CARRIAGE MEADOWS SOUTH AT LORSON RANCH FILING NO. 2 El Paso County, Colorado LANDSCAPE PLAN

L1 OF 4

6 L2 GRASSES AND PERENNIALS PLANTING DETAIL NTS

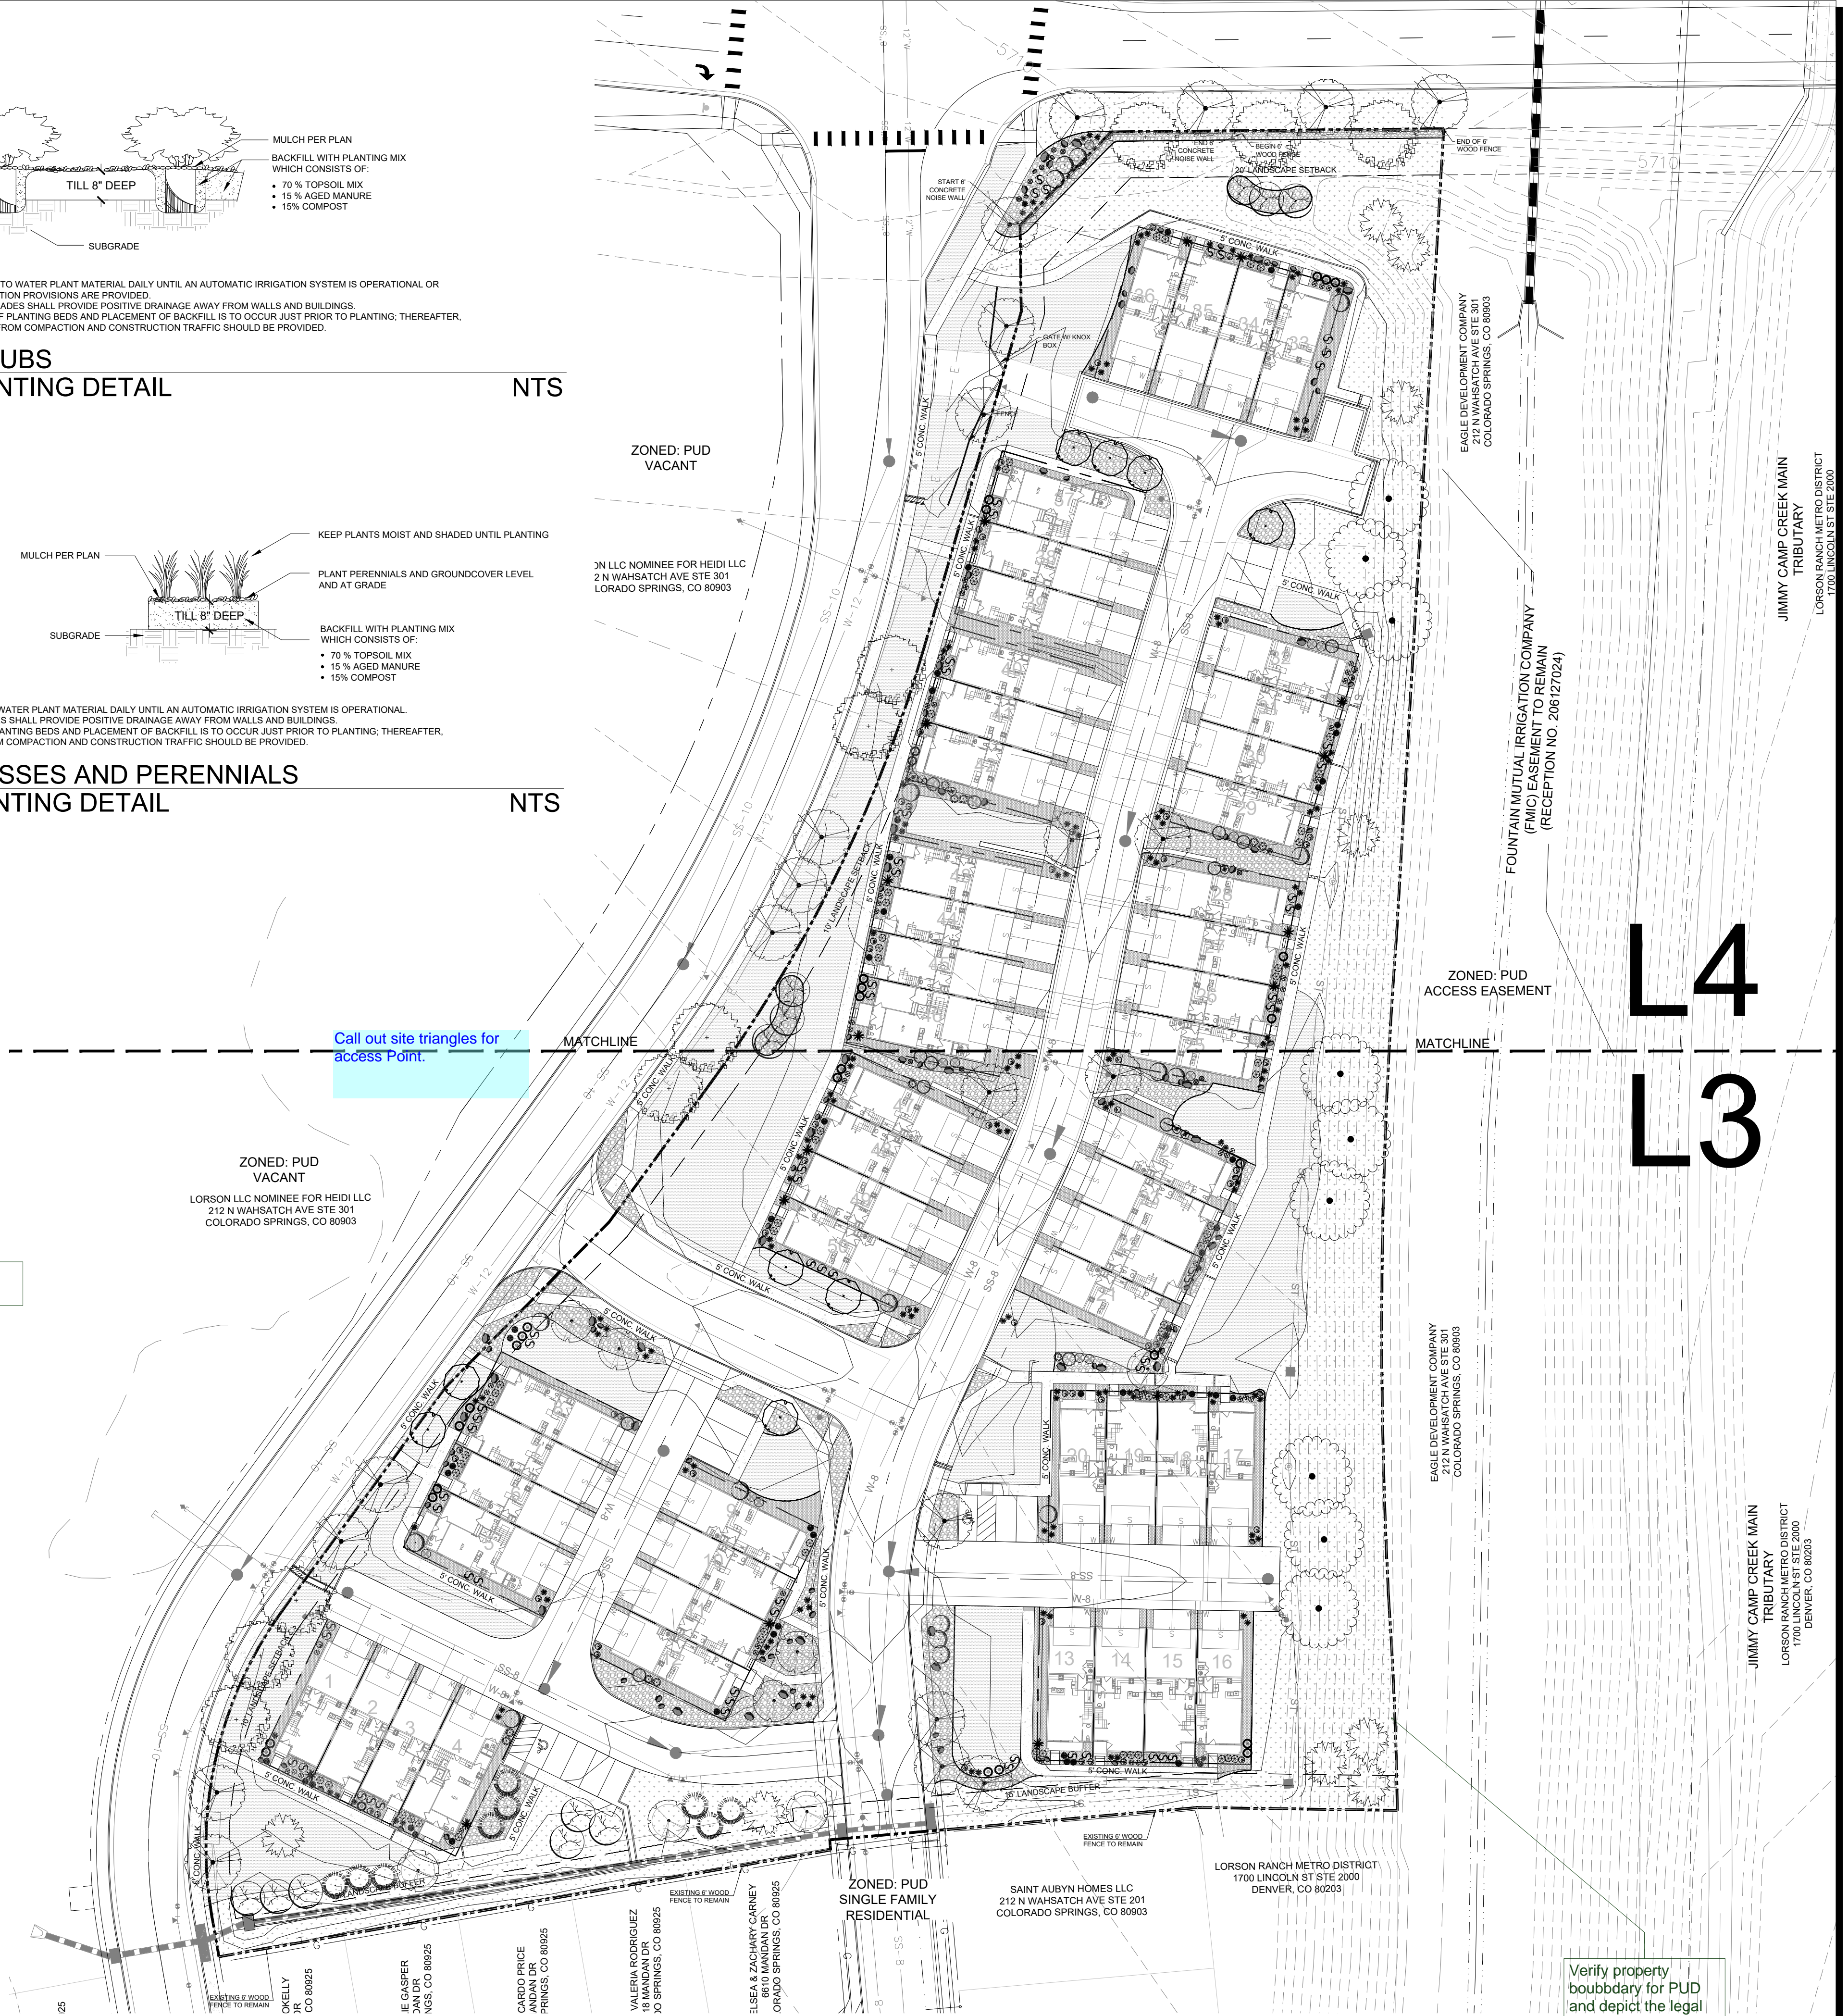
Verify property boundary for PUD and depict the legal for the PUD on all sheets 1-8

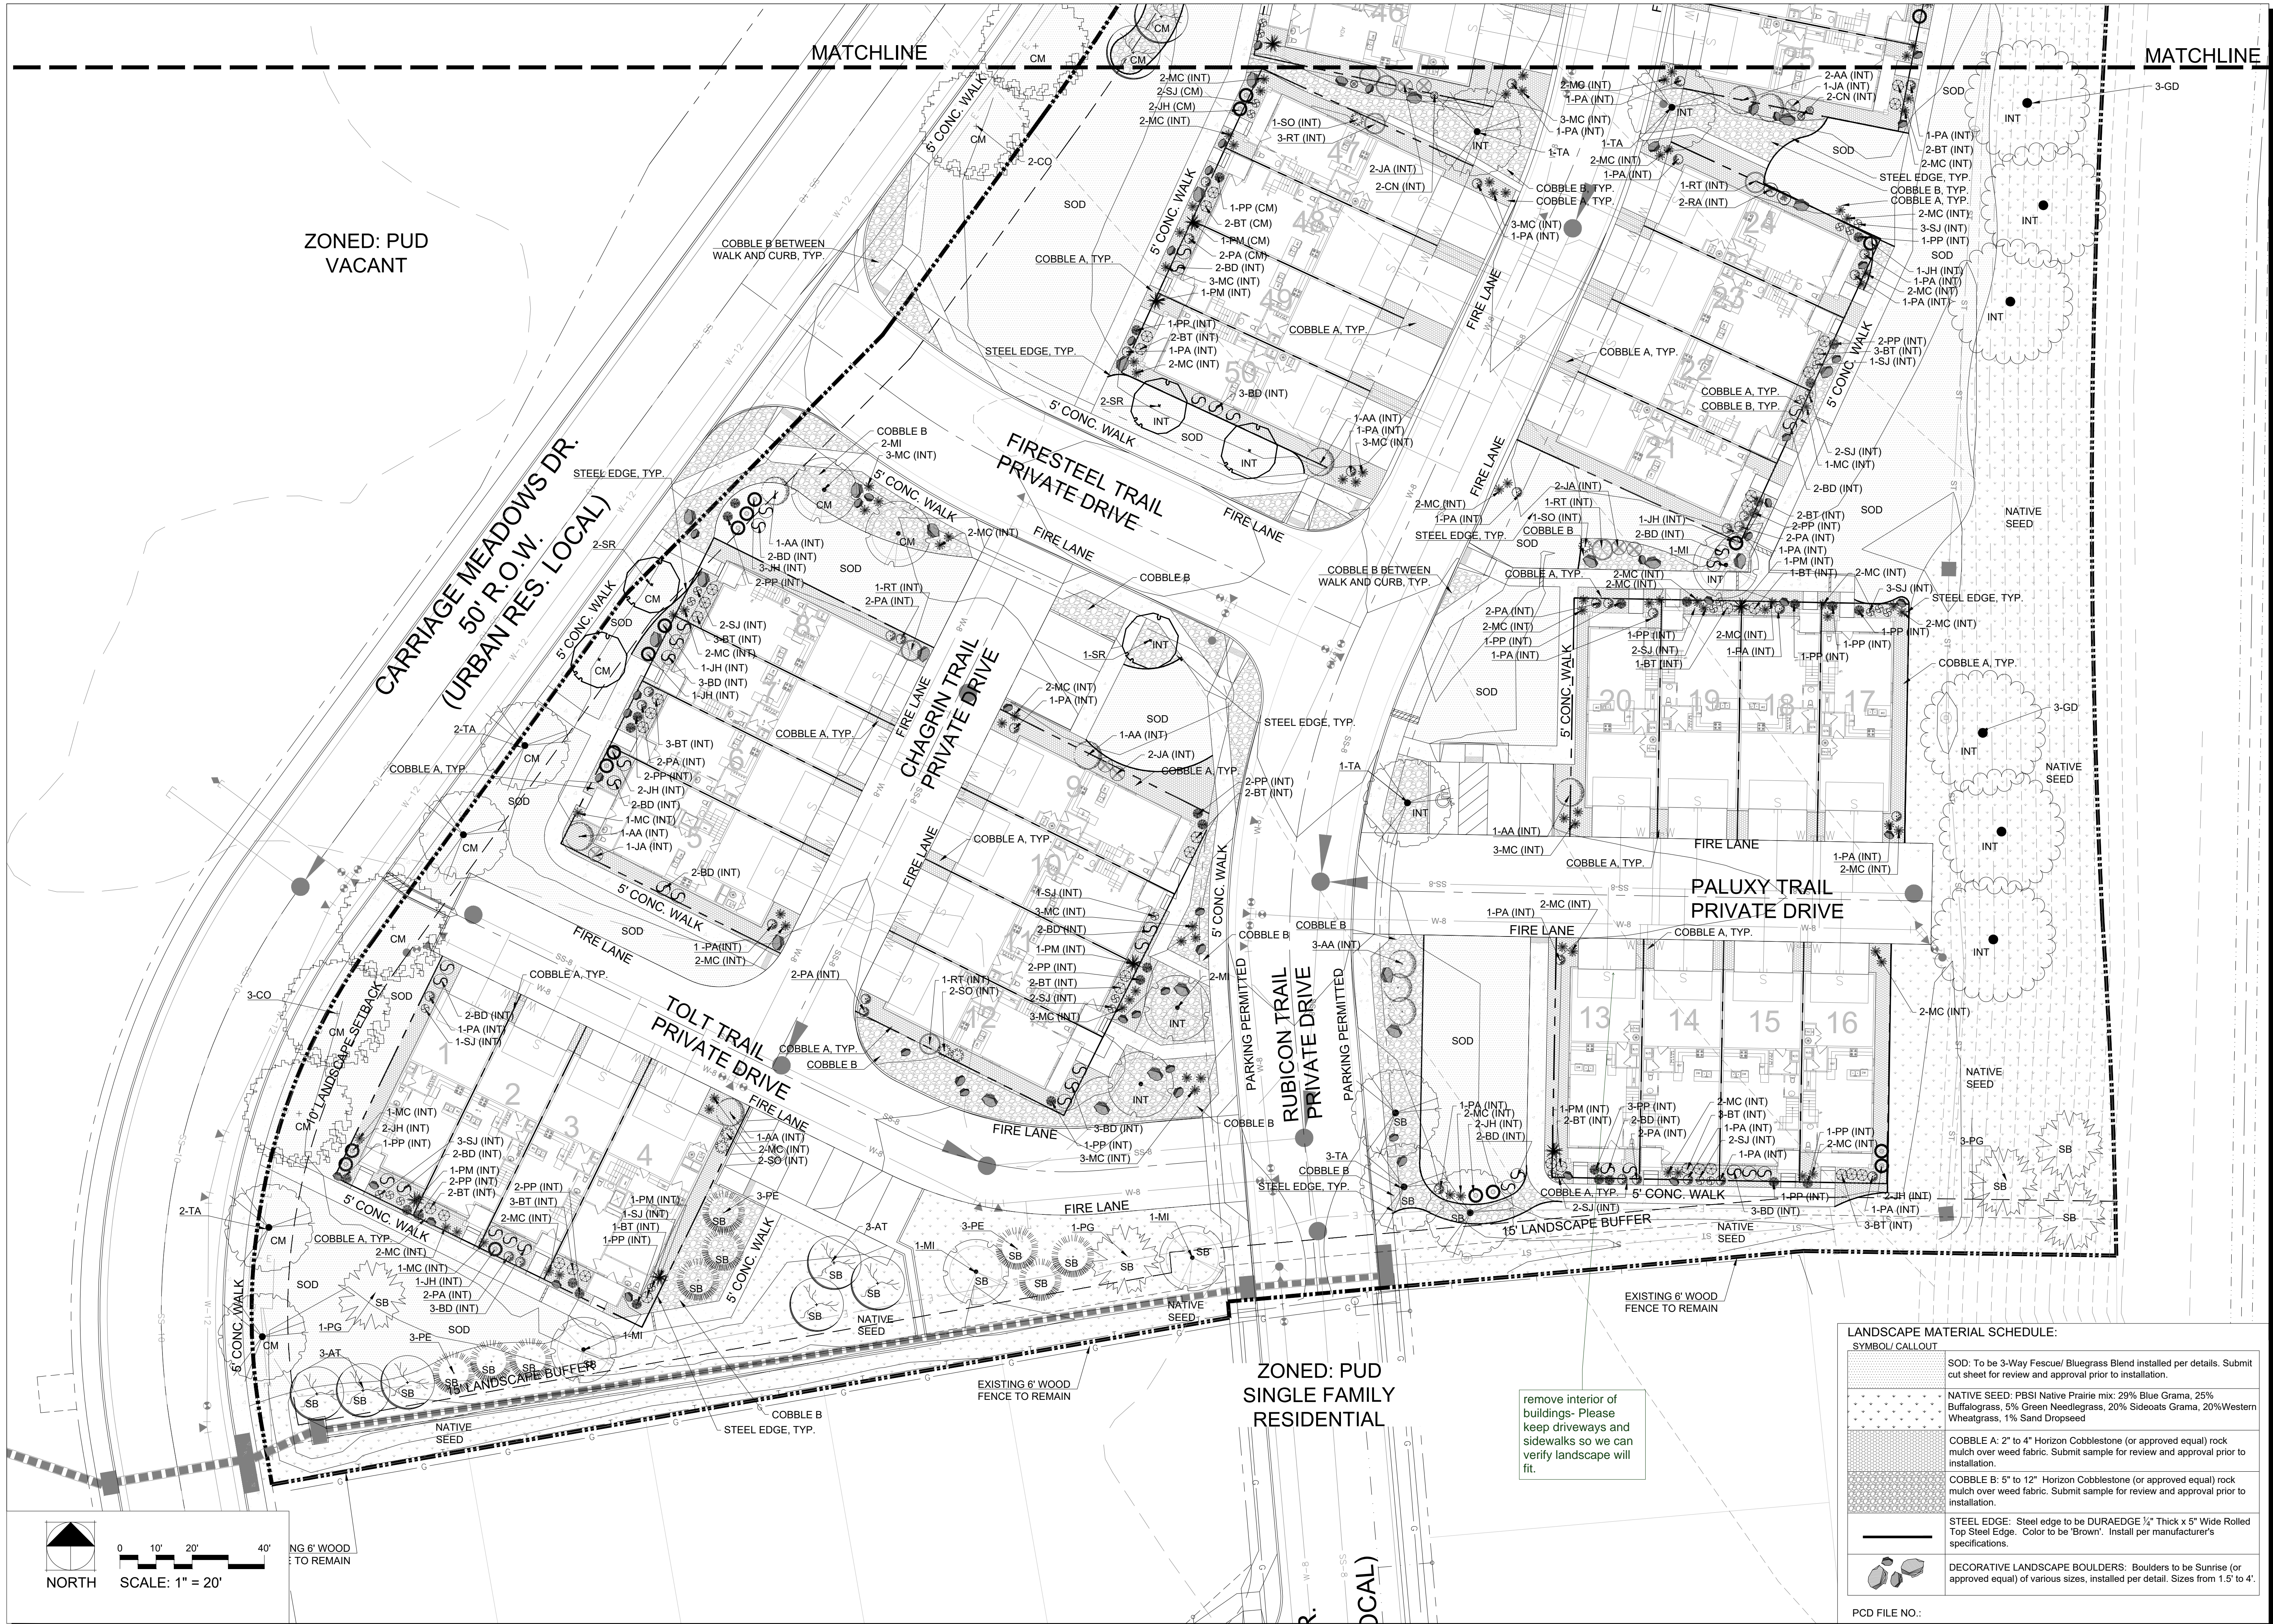
remove interior of buildings- Please keep driveways and sidewalks so we can verify landscape will fit.
